CHANGE ORDER

No. 1-01

PROJECT: 2022 Capital Outlay Project OWNER: Ogdensburg City School District 1100 State Street Ogdensburg, New York 13669 CONTRACTOR: Barrett Paving Materials (Name, Address) 26572 NYS Rt. 37 Watertown, NY 13601 CONTRACT FOR: No. 1 - Site CONTRACT DATE: August 22, 2022	DATE OF ISSUANCE: November 2, 2022 ENGINEER: BCA Architects & Engineers 15 Public Square Watertown, New York 13601 ENGINEER'S PROJECT NO.: 2022-013 SED PROJ. MGR.: Wendy Clark SED CONTROL NO.: 51-23-00-01-0-006-013 John F. Kennedy
---	---

Re: **JC-L1 Additional Sidewalk**

1. NEW ASPHALT DRIVE LAYOUT PLAN

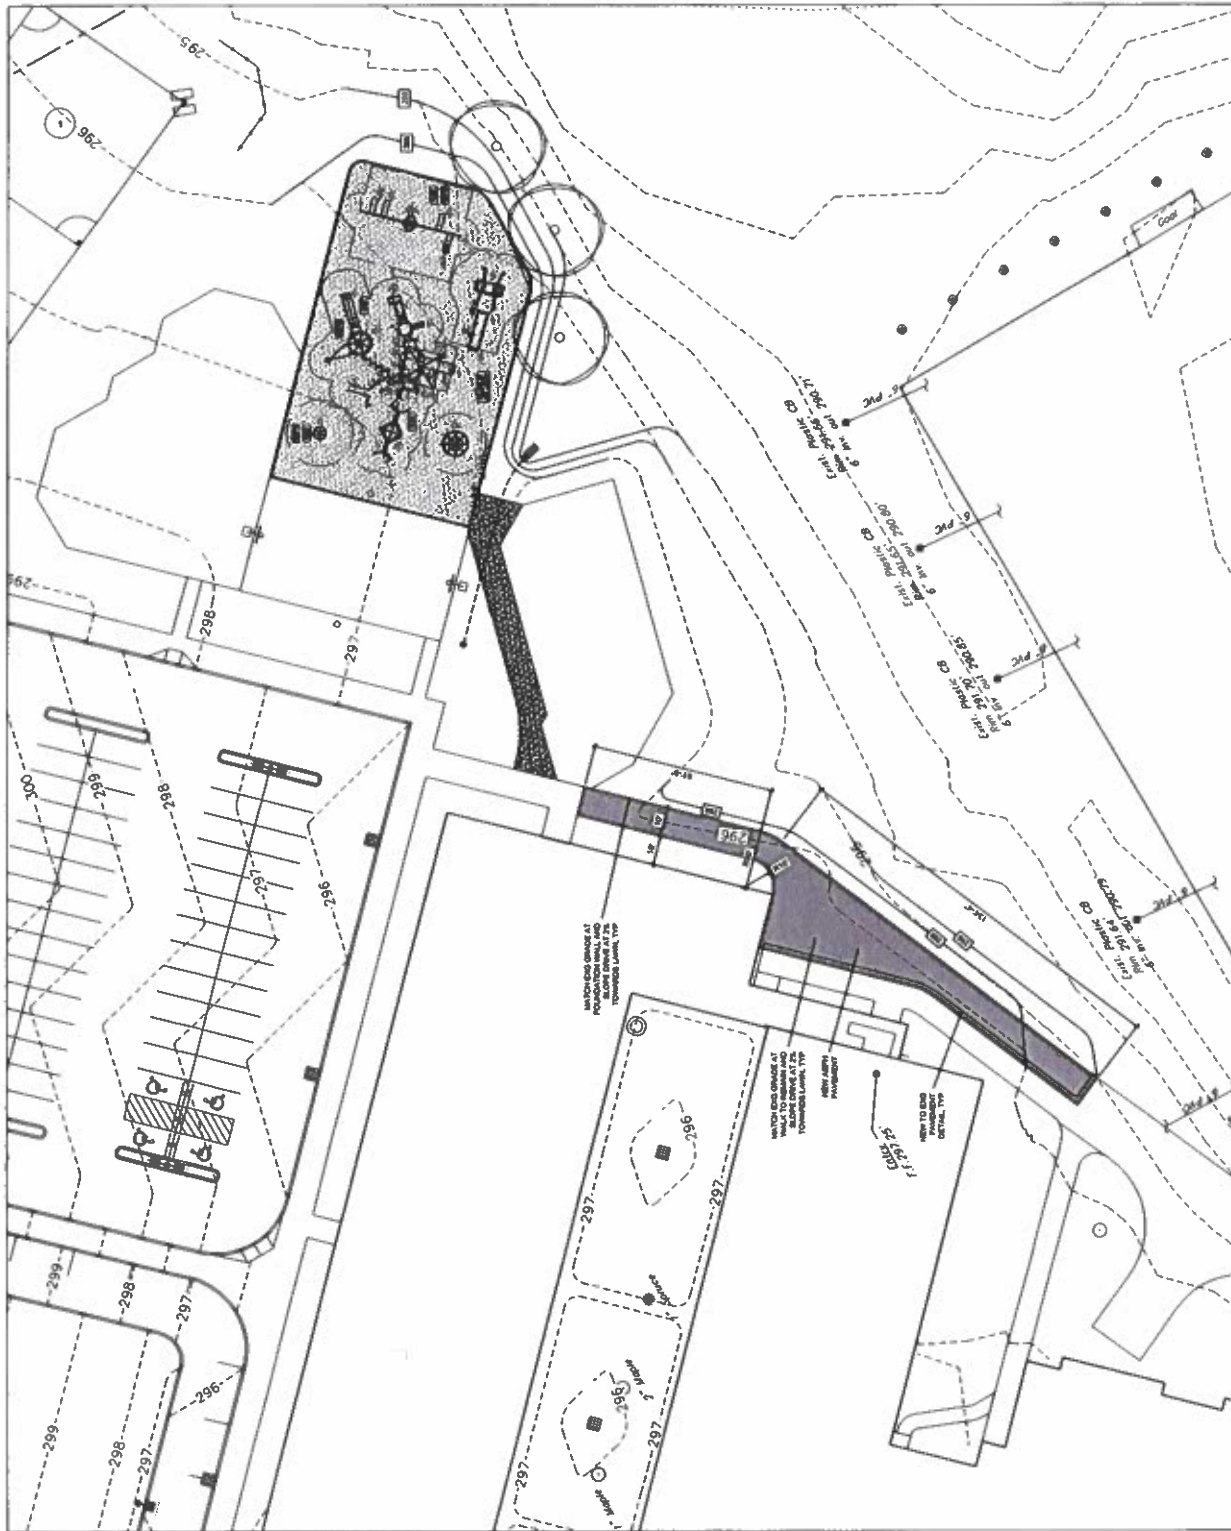
Add to provide an asphalt drive/walkway connection around the rear of the building to accommodate pedestrians as well as maintenance vehicles as per Contract Drawing JC-L1. \$ 33,844.50

Excavate approx. 155 CY, place 12 inches of Type 2 subbase on geotextile fabric. Finegrade area for asphalt. Pave area(327 SY) with 3.5" of Type 3 Binder Course HMA and 1.5" of Type 6 Top Course HMA. Apply Tackcoat between lifts. Topsoil Edges and seed disturbed areas.

D Add to provide an asphalt drive/walkway connection around the rear of the building to accommodate pedestrians as well as maintenance vehicles as per Contract Drawing JC-L1.

PLAYGROUND LAYOUT PLAN
SCALE: 1"=10'-0"

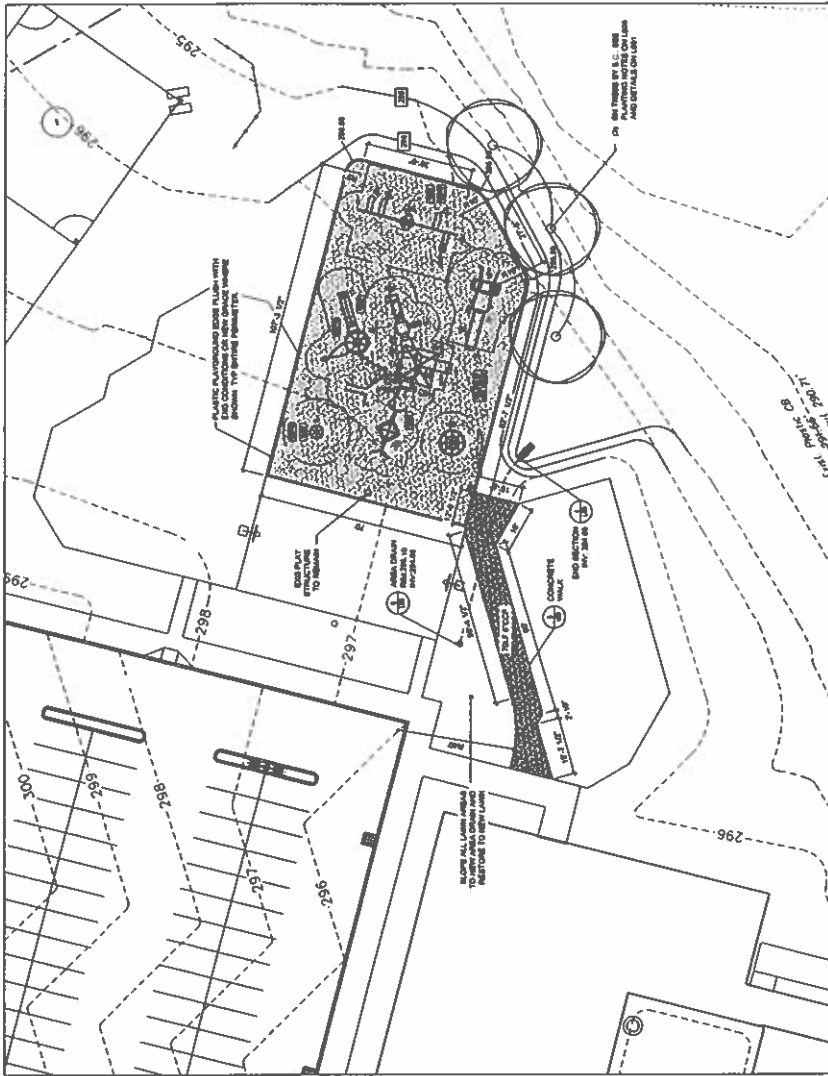
NOTE: 6" DEPTH EXCAVATION TO SUBGRADE ELEVATIONS. DISPOSE OF EXCESS SOILS AND COMPACTION TO 95% FOR THE PLAYGROUND AREA IS BY SITE CONTRACTOR.
